Technical Bulletin: 7

Controller Upgrade (ECAP14A)

Affected Product: ECAP14, RMC Controllers

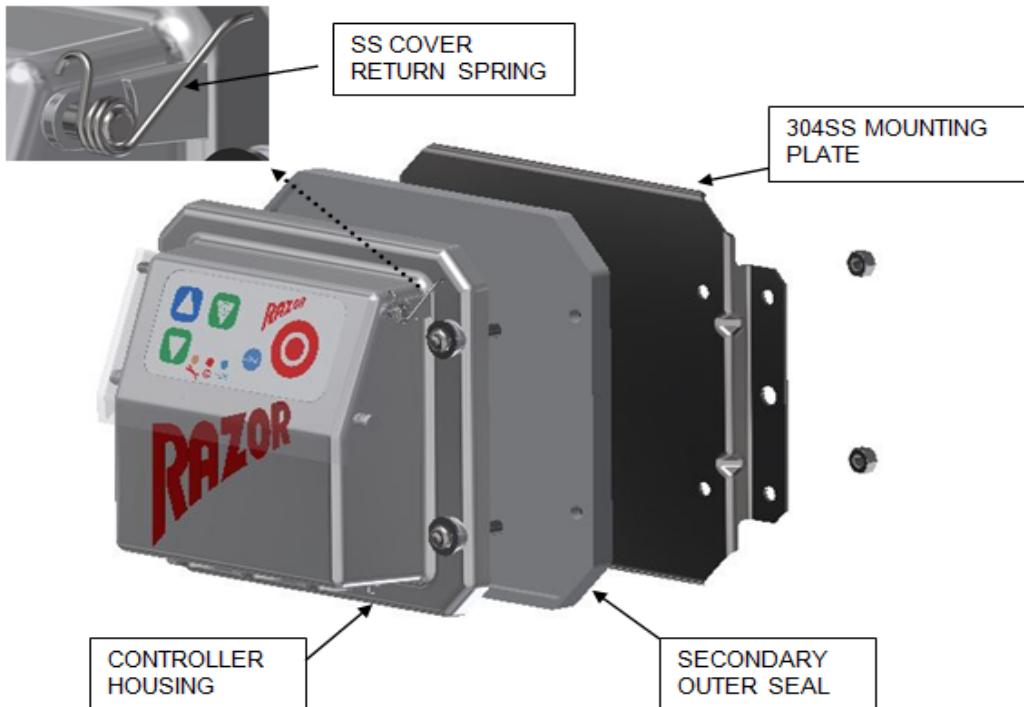
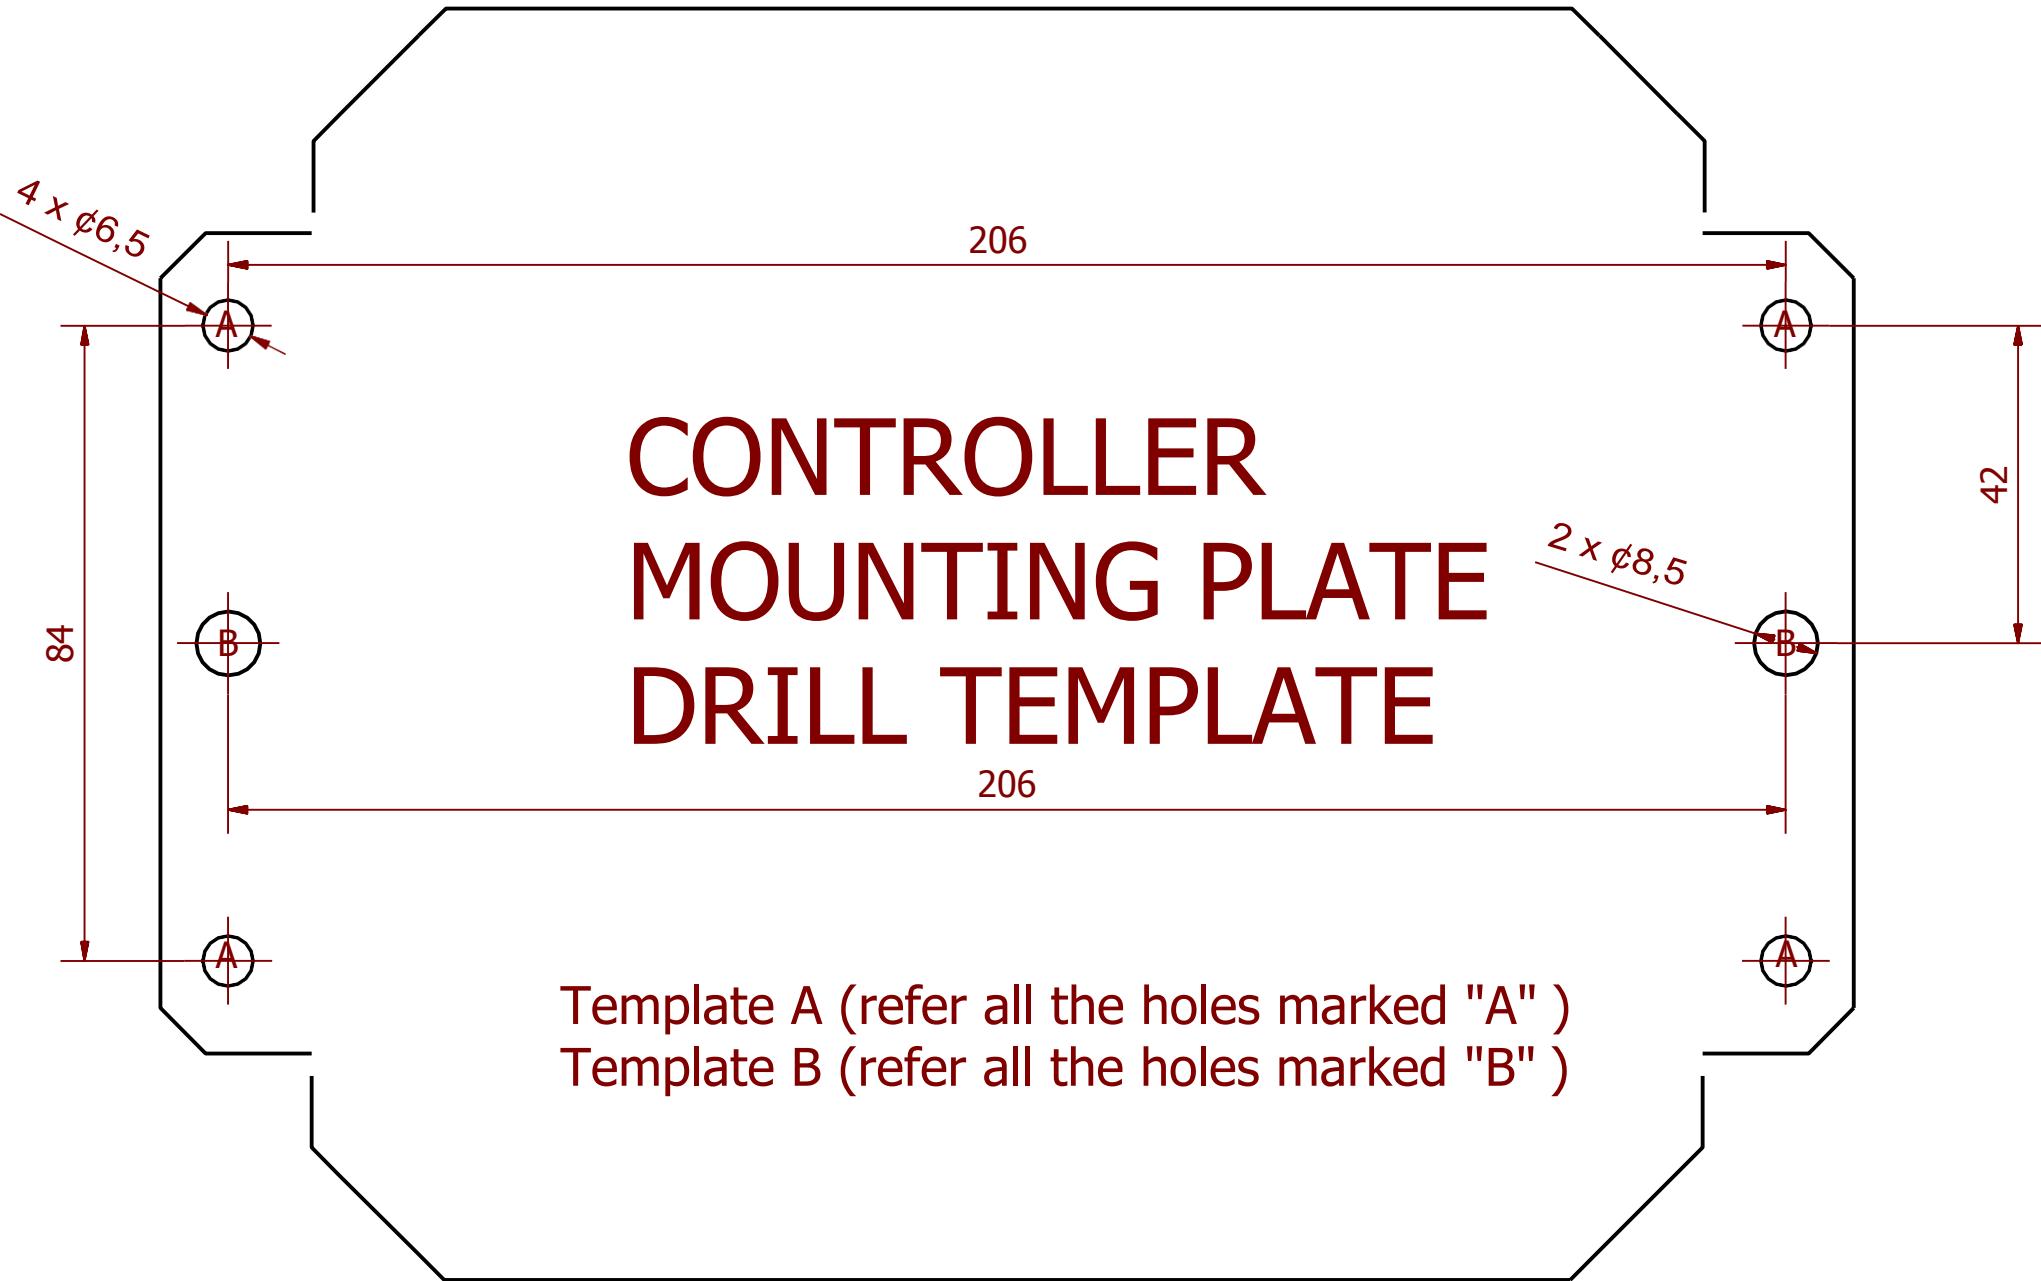
Razor International has made several upgrades on the controller housing listed below

1. 304 Stainless steel mounting plate added
2. Secondary outer seal added
3. Stainless steel cover return spring added

The upgrades have been implemented to improve the longevity of controller housing and watertight integrity.

Always use mounting plate and seal on new installation.

1. **THESE ADDITIONAL COMPONENTS SHOULD NOT BE REMOVED OR SUBSTITUTED AS IT MAY VOID WARRANTY.**
2. **ALSO, IT MAY VOID WARRANTY IF THE PLUGS ON THE CONTROLLER ARE CUT**
